TECHNICAL MEMORANDUM

TO: Andrew Burns - Southern Nevada Water Authority
Jim Watrus - Southern Nevada Water Authority **HCI-1827**

SUBJECT: Additional Comments on *FEMFLOW3D* Documentation and Review of Source Code

DATE: June 6, 2006

Comparison of Drawdowns at Various Distances from Pumping Well Calculated by *FEMFLOW3D* Using Three Solvers to those Calculated by Theis Solution

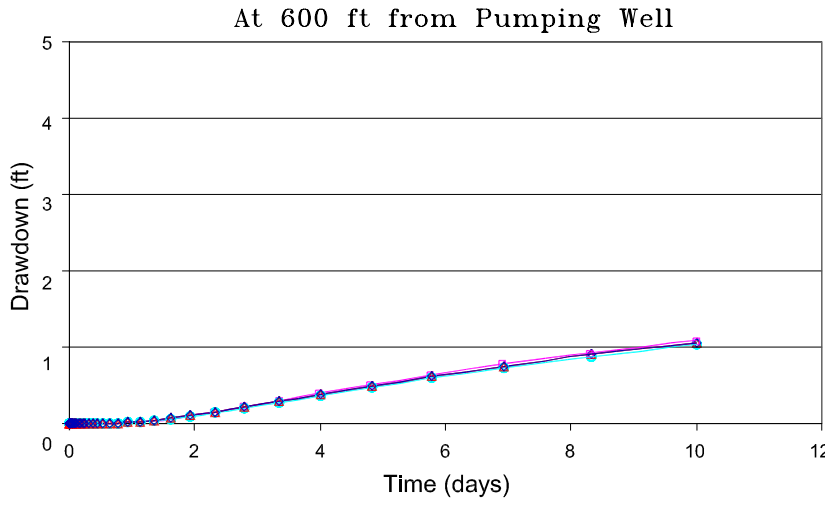
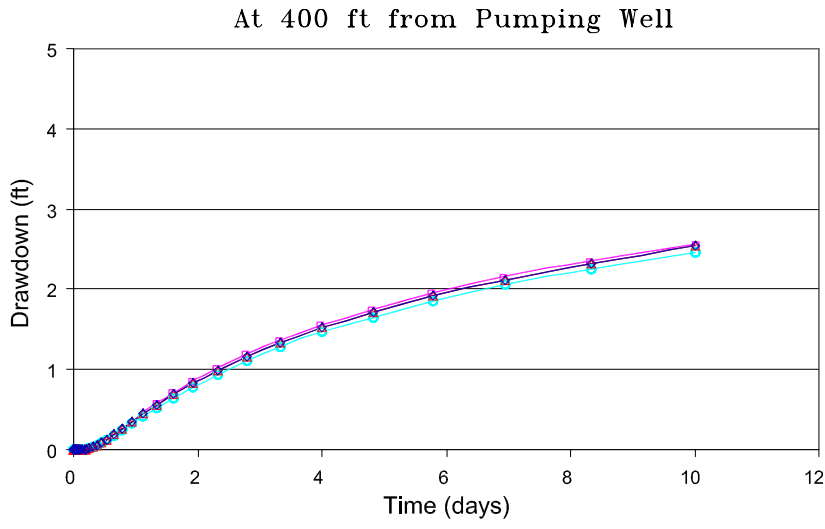
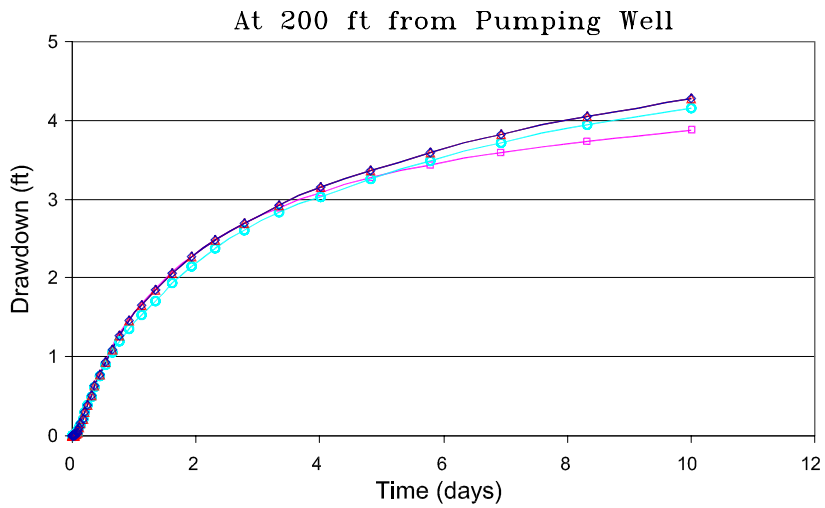
Figure 1 compares the drawdowns calculated by the three solvers from *FEMFLOW3D* with those from the Theis analytical solution. In general, the results from all three solvers are in close agreement with the analytical solution.

Comparison of Drawdowns at Various Distances from Pumping Well Calculated by FEMFLOW3D Using Three Solvers to those Calculated by Papadopulos Solution

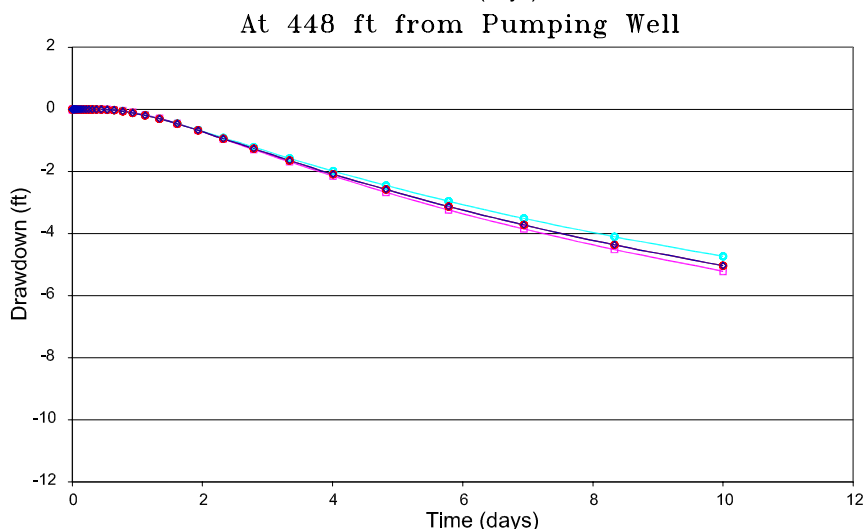
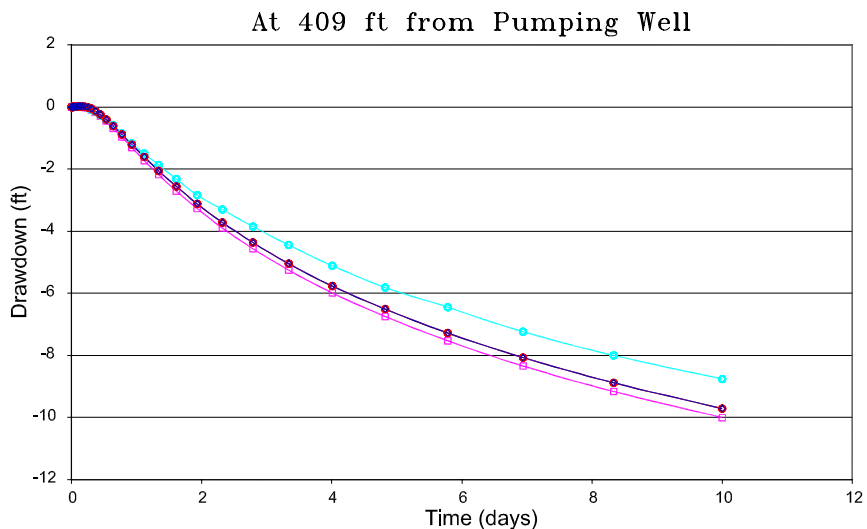
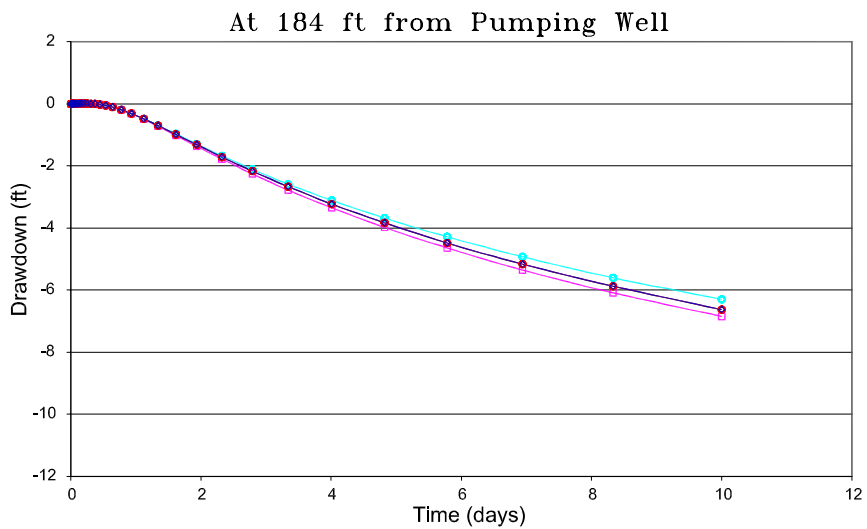
Figure 2 shows that the simulated results from the **CG Method** and **Over-Relaxation Method** are in close agreement with each other and in close agreement with the Papadopoulos analytical solution. The simulated results from the **MG Method** with default parameters are not in as close agreement with the results from the analytical solution as those from the **CG** or the **Over-Relaxation Methods**. It is not clear why the solution from the MG Method diverges from the analytical solution at 409 ft from the pumping well in comparison with those from 184 ft and 448 ft from the pumping well.

Comparison of Drawdowns at Various Depths at Distance of 200 ft from Pumping Well Calculated by *FEMFLOW3D* Using Three Solvers to those Calculated by Neuman Solution

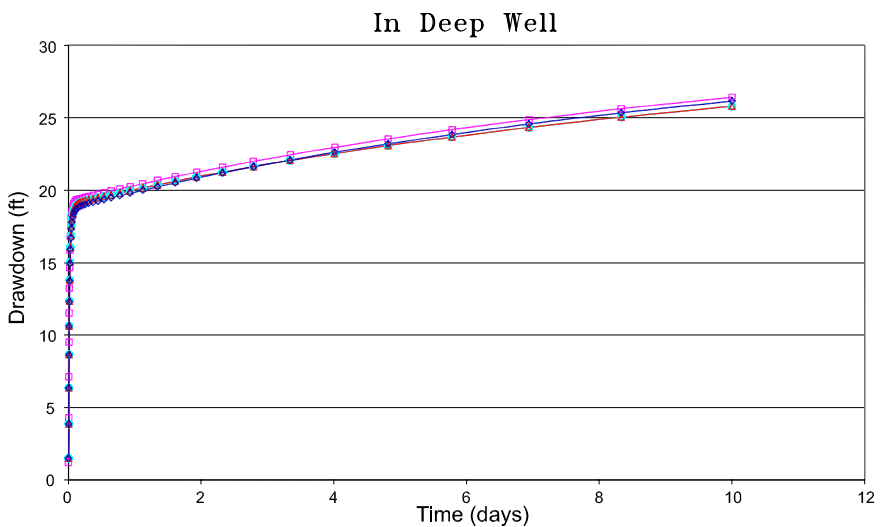
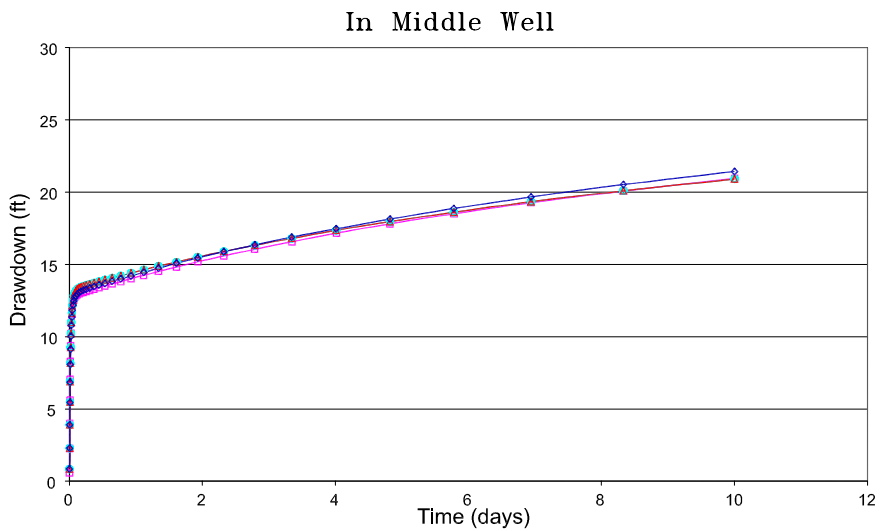
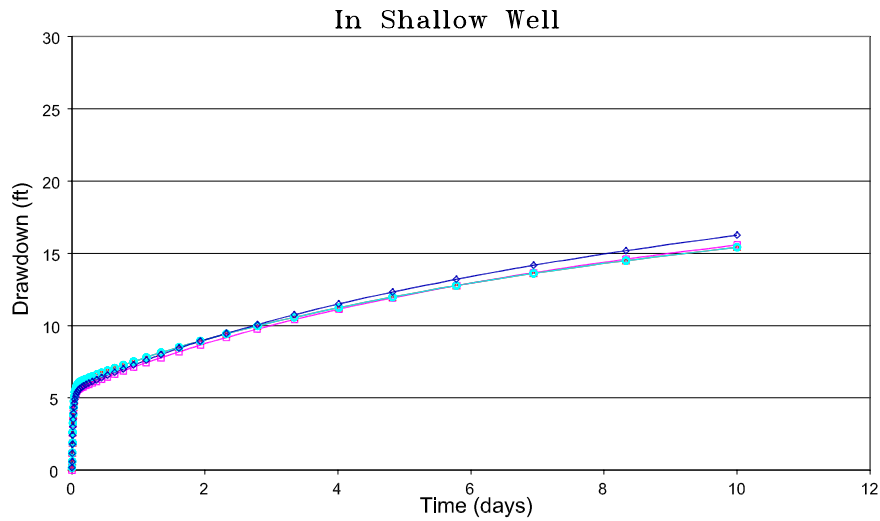
In Figures 3 and 4, results from the **MG Method** are in closer agreement with the Neuman analytical solutions than those from the **CG** and **Over-Relaxation Methods**.
